Clutch Coil Harness Connection on Early Model Compressors: 6512102 & 6512103

Early designs of gpd compressors 6512102 and 6512103 for the applications listed below may require the OEM clutch coil wire harness. Late model designs of these gpd compressors are equipped with the wire harness.

6512102
Late model design with wire harness

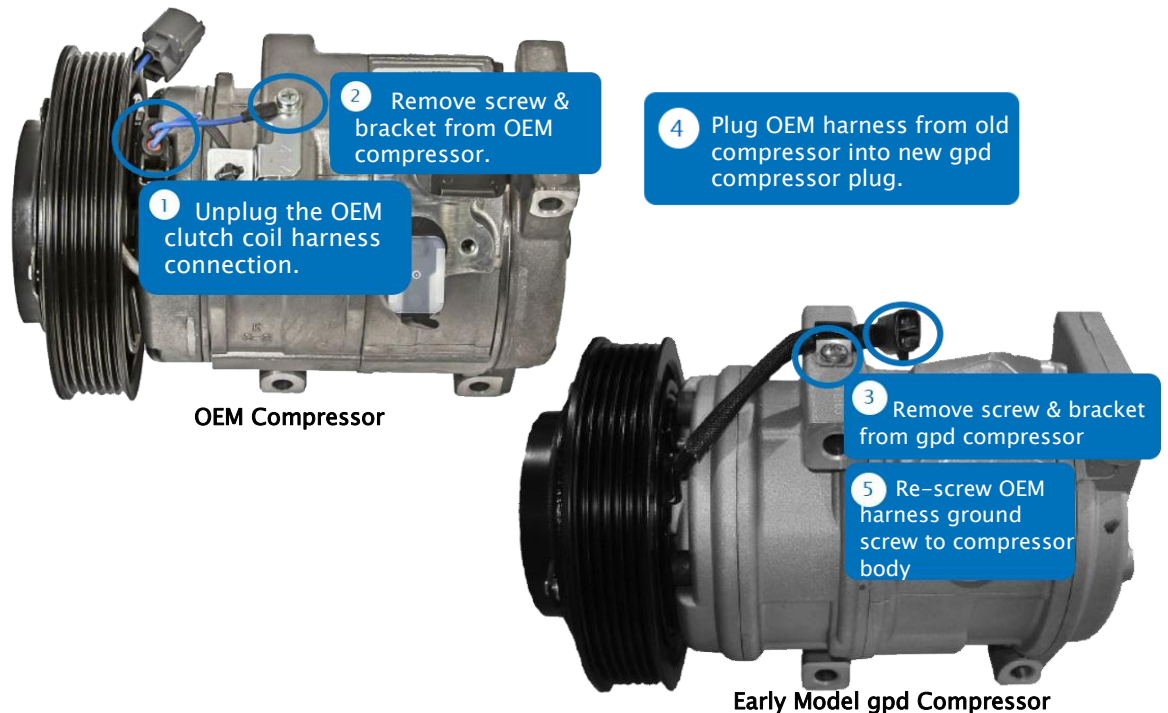
If the gpd compressor, 6512102 or 6512103, on hand does not feature the clutch coil harness circled on the late model designs pictured above, it is an early model design and will require the OEM clutch coil wire harness for installation.
